Office Action Summary	Application No. 10/563,338	Applicant(s) LAGLER, LOUIS	
	Examiner ANDREW T. KIRSCH	Art Unit 3781

DETAILED ACTION

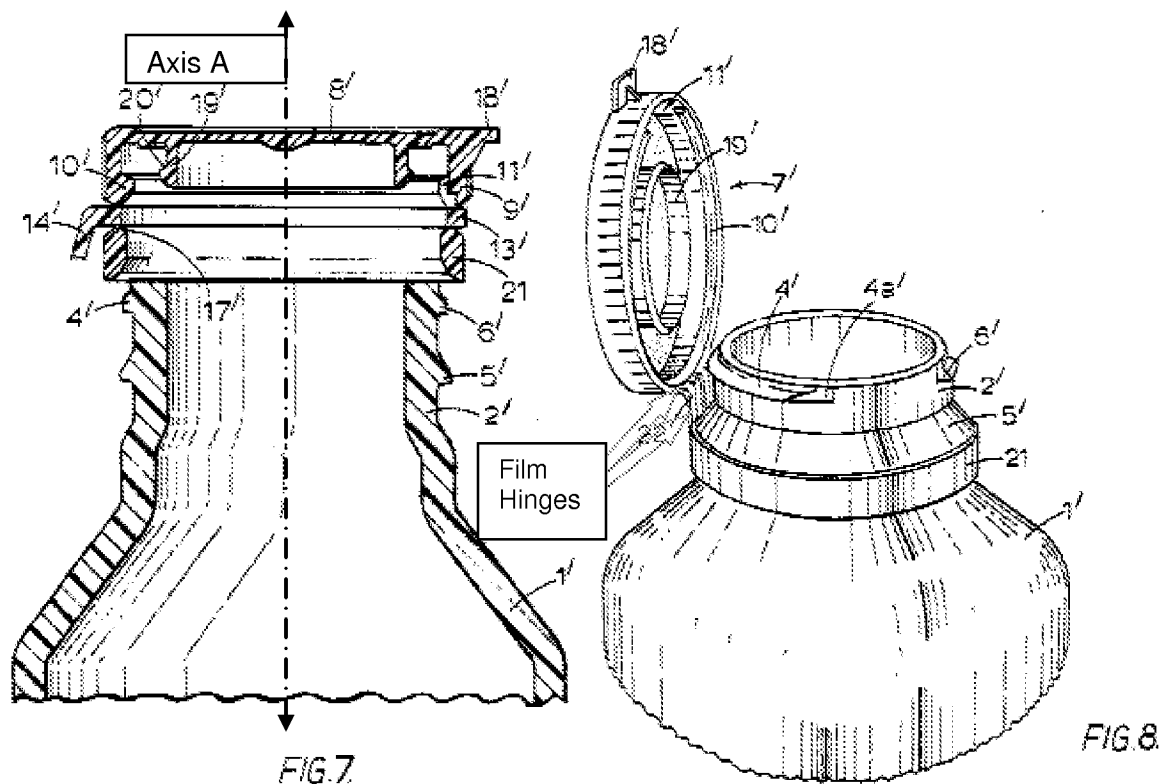
9. In re Claim 1, with reference to Figs. 7 and 8 below, Wheeler discloses: A closure moulded in closed position with

- a ring shaped body (21), the ring shaped body having an opening extending in an axial direction and having substantially the same diameter at both ends (see Fig. 7), comprising fixing means (17) to fix the closure on a neck (2') of a bottle (1'), the fixing means having substantially the same diameter as the opening (see Fig. 7), and

- a lid (7), the lid having substantially the same diameter as the ring shaped body (see fig. 7), the lid comprising a sealing means (19', 20') to seal an orifice (2') of the bottle, the sealing means directly contacting the neck of the bottle (column 3, lines 52-54), whereby the body (21) and the lid (7) are separated from each other by a circumferential gap (see Fig. 7), and

- a snap hinge comprising a first element (22) and a pair of film hinges (see Fig. 8) defining a plane, the pair of film hinges connecting the first element (22) to the lid (7) and to the body (21), whereby the plane is arranged substantially parallel to an axis A (Fig. 7) of the closure.

10. Wheeler does not disclose wherein the snap hinge comprises a first and second trapezoid element, or a second pair of film hinges defining a second plane.

Fig. 7 of Rentsch et al.

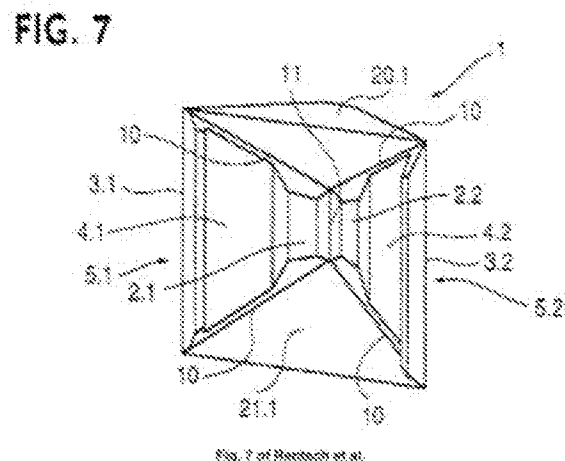
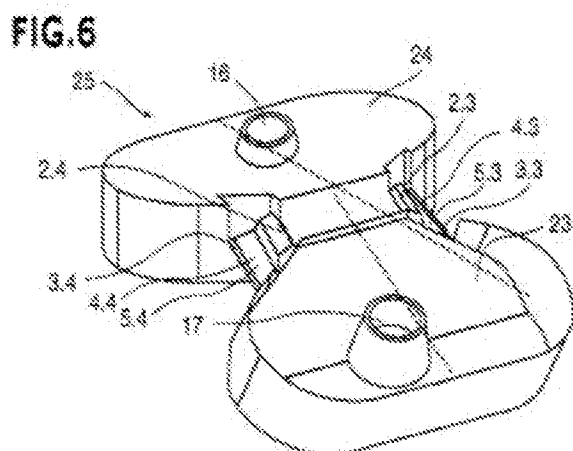
11. However, with reference to Figs. 6 and 7 below, Rentsch et al. discloses a closure wherein a snap hinge comprises a first and second trapezoid element (5.3, 5.4), and a second pair of film hinges (10) defining a second plane.

12. Therefore, it would have been obvious to one of ordinary skill in the art at the time of the invention to have shaped the element of the closure of Wheeler as a trapezoid and to have duplicated the number of elements as taught by Rentsch et al. for the purposes of strengthening the hinge joint and achieving a preferred snapping movement of the lid (column 3, lines 39-54).
